Economic Commission for Europe**Inland Transport Committee****World Forum for Harmonization of Vehicle Regulations****176th session**

1958 Agreement:**Consideration of draft amendments to existing****UN Regulations submitted by GRE****Proposal for Supplement 11 to the 06 series of amendments
to UN Regulation No. 48 (Installation of lighting and light-
signalling devices)****Submitted by the Working Party on Lighting and Light-Signalling*****Revision 1**

Supplement 11 to the 06 series of amendments to UN Regulation No. 48 (Installation of lighting and light-signalling devices)

"Part 5 – Example of illuminating surface in comparison with light-emitting surface in the case of a "single function lamp" (see paragraphs 2.10.2. to 2.10.3. of this Regulation)

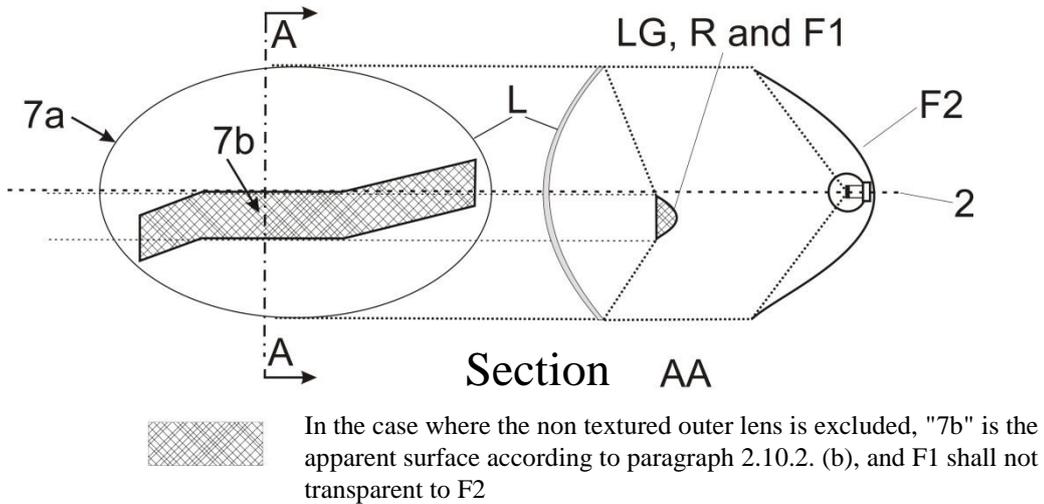
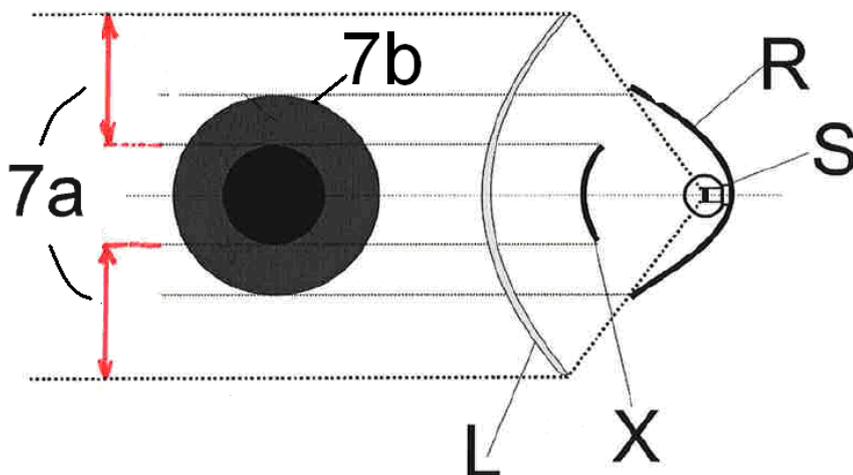
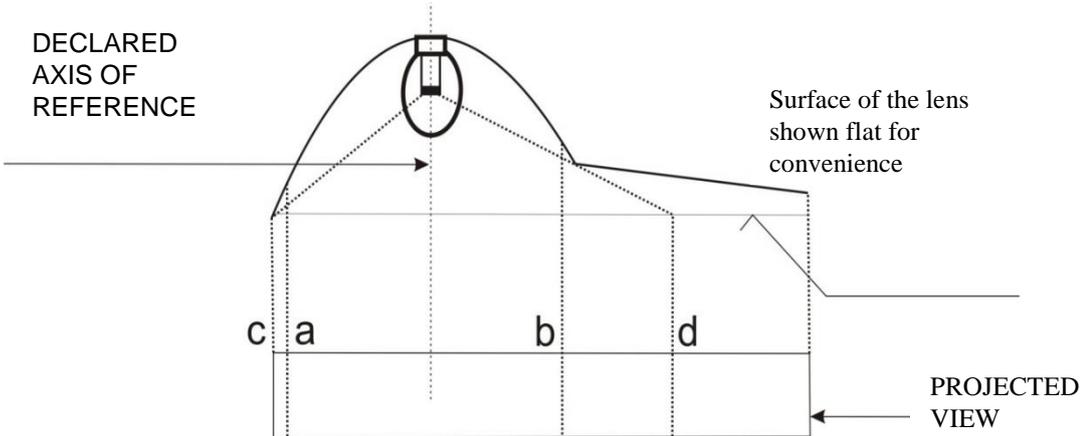
Part 5, amend to read:

In the case where the non-textured outer lens is excluded, "7b" is the apparent surface according to paragraph 2.10.2. (b).

Example of a light guide optic or a reflector optic behind an outer lens:

Example of a light source with a reflector optic in combination with an area which is not part of this function, behind an outer lens:

In the case where the non textured outer lens is excluded, "7b" is the apparent surface according to paragraph 2.10.2. (b).

Part 6, amend to read:

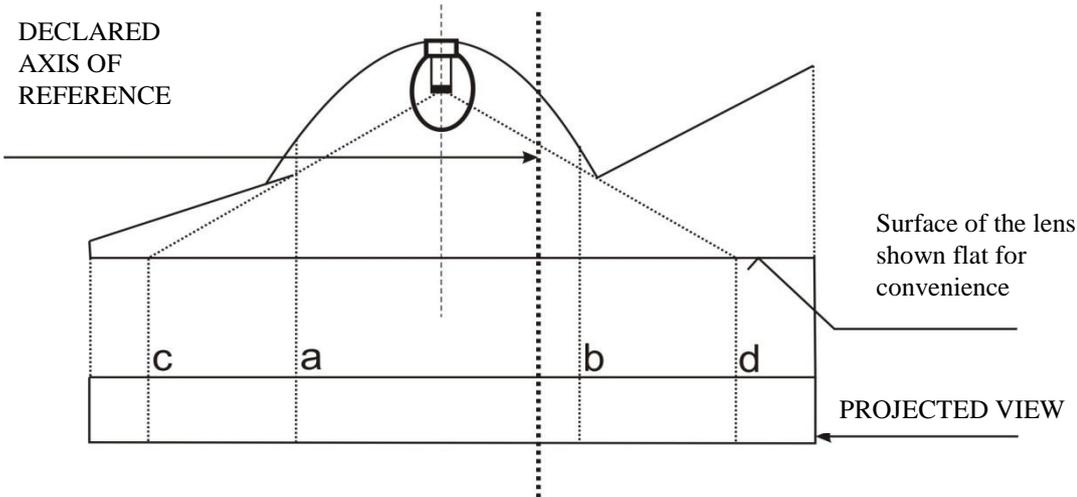
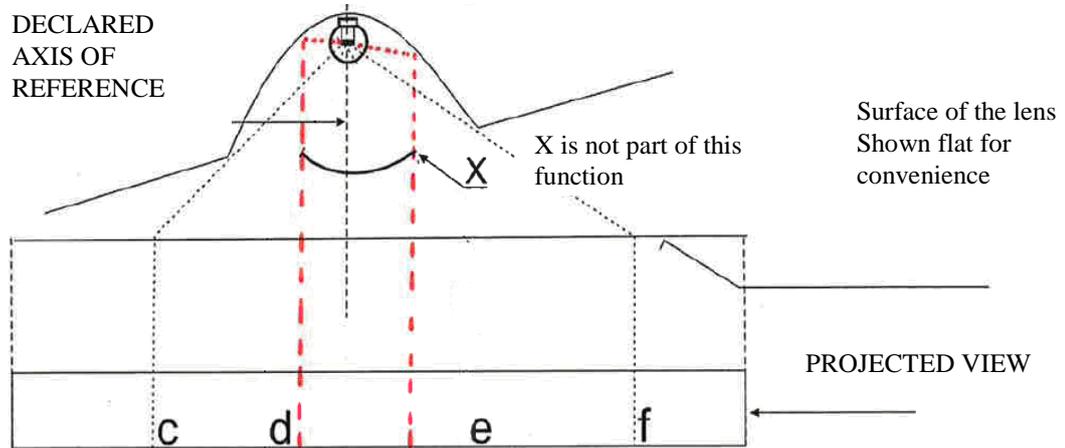
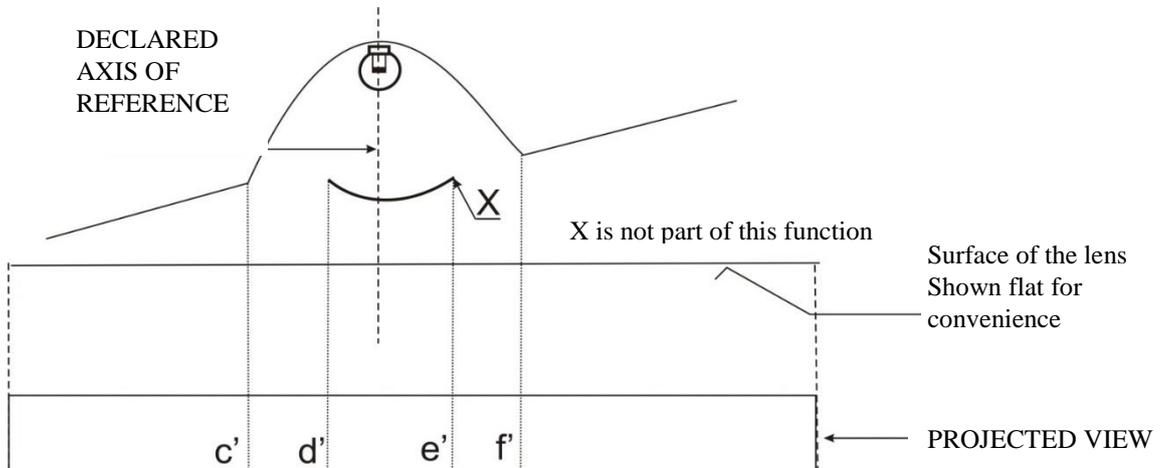
Example A

<i>Illuminating surface</i>	<i>Declared light-emitting surface according to 2.10.2. (a)</i>
Edges are	a and b	c and d

Example to determine a light emitting surface according to 2.10.2. (a) in combination with an area which is not part of the function:

<i>Declared Light-emitting surface according to 2.10.2. (a)</i>
Edges are	c-d and e-f

Example to determine the apparent surface in combination with an area which is not part of the function and a non-textured outer lens (according to 2.10.2. (b)):

<i>Declared Light emitting surface according to 2.10.2. (b) for example</i>
Edges are	c'-d' and e'-f'

Part 7, amend to read:

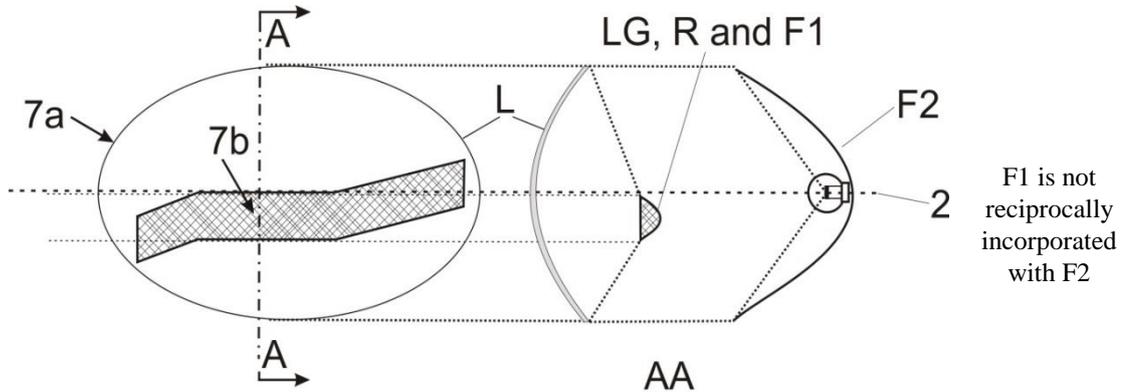
In the case where the non-textured outer lens is excluded, "7b" is the apparent surface according to paragraph 2.10.2. and F1 shall not be transparent to F2:
